DESIGN CP	DRAWN BY PH	DART AEROSPACE USA, INC. PORT HADLOCK, WA	
CHECKED [Signature]	APPROVED [Signature]	DRAWING NO. D3274	REV. D SHEET 1 OF 4
DATE 06.12.19		TITLE SKIDTUBE ASSEMBLY	SCALE NTS
A	04.03.15	NEW ISSUE	
B	04.08.09	MOVE SADDLE HOLE: 42.14 WAS 42.76	
C	05.03.16	ADD -043; NEW INSERTS	
D	06.12.19	NEW INSERTS, SS WEARSHOE + GASKET

DRAWING NO. D3274	TITLE SKIDTUBE ASSEMBLY	REV. D	<b>DART AEROSPACE USA, INC</b> <b>ENGINEERING ORDER</b>	D.E.O. NO. D3274-D-1	SHEET NO. SHEET 1 OF 1	SCALE NTS
DRAWN <i>UP</i>	CHECKED <i>[Signature]</i>	MFG. APPR. <i>[Signature]</i>	APPROVED <i>[Signature]</i>	DE APPR. <i>[Signature]</i>		
DATE 09.06.17	DATE 09.06.23	DATE 09/06/23	DATE 09/06/23	DATE 09.06.23

### DETAIL F: END FINISHING DETAIL

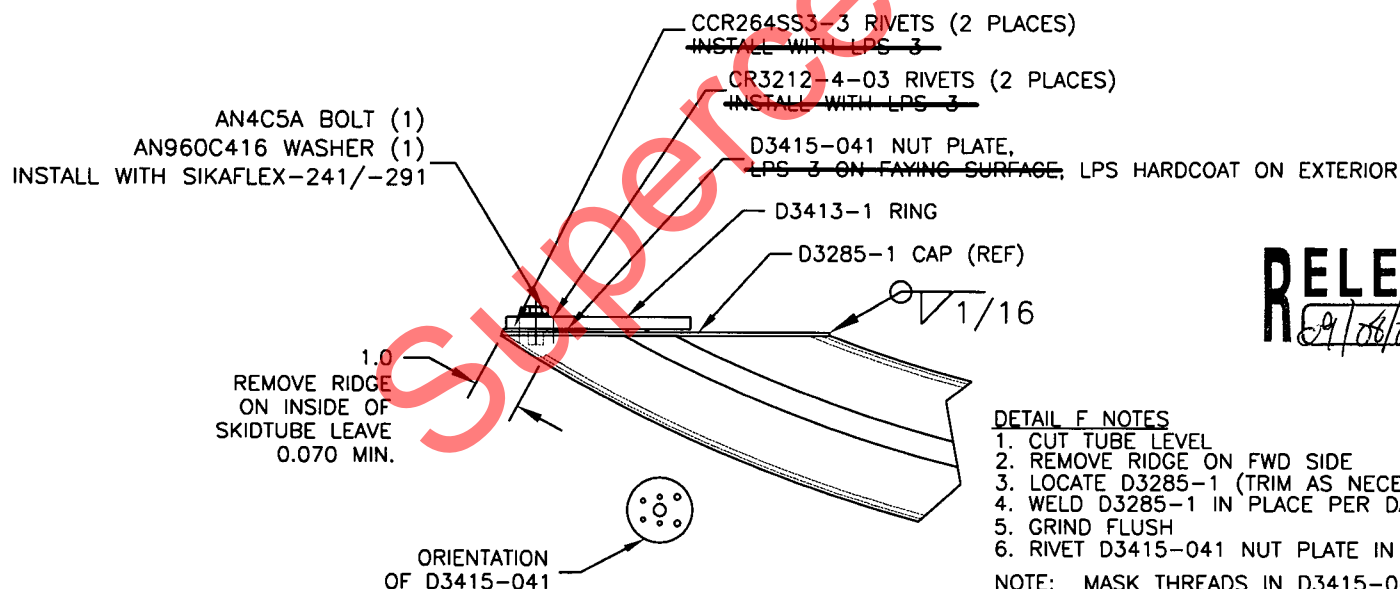
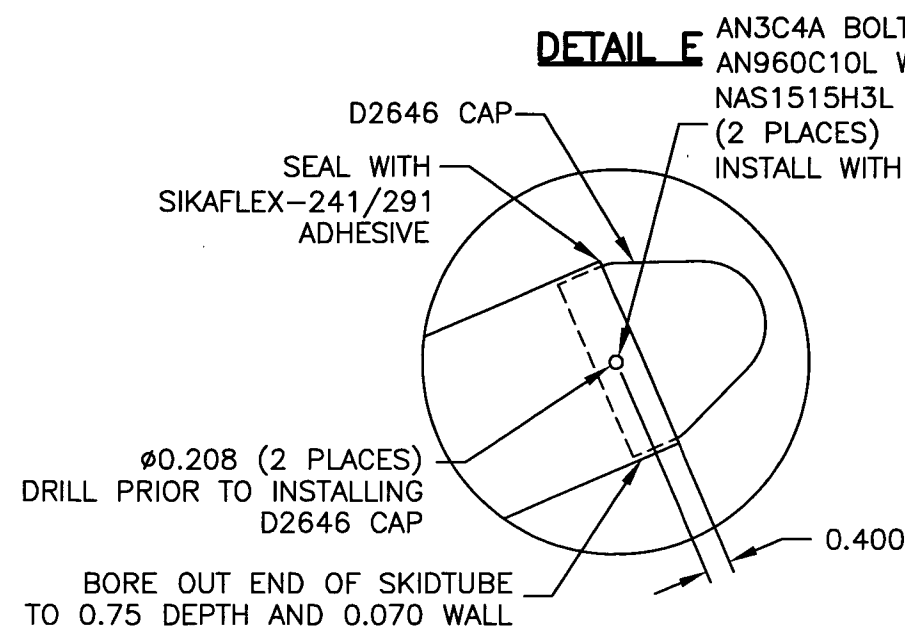
AMEND DETAIL F AS SHOWN:

1. CUT TUBE LEVEL
2. REMOVE RIDGE ON FWD SIDE
3. LOCATE D3285-1 (TRIM AS NECESSARY)
4. WELD D3285-1 IN PLACE PER DART QSI 004
5. GRIND FLUSH
6. RIVET D3415-041 NUT PLATE IN PLACE

NOTE: MASK THREADS IN D3415-041  
PRIOR TO FINISH
